# City of Mississauga Department Comments

Date Finalized: 2023-09-06 File(s): A329.23

Property Address: 1649 Birchwood Dr

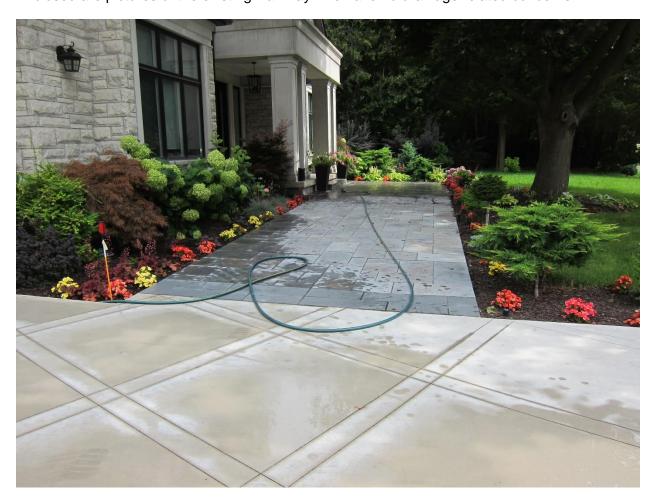
Enclosed are pictures of the existing walkway. We have no drainage related concerns.
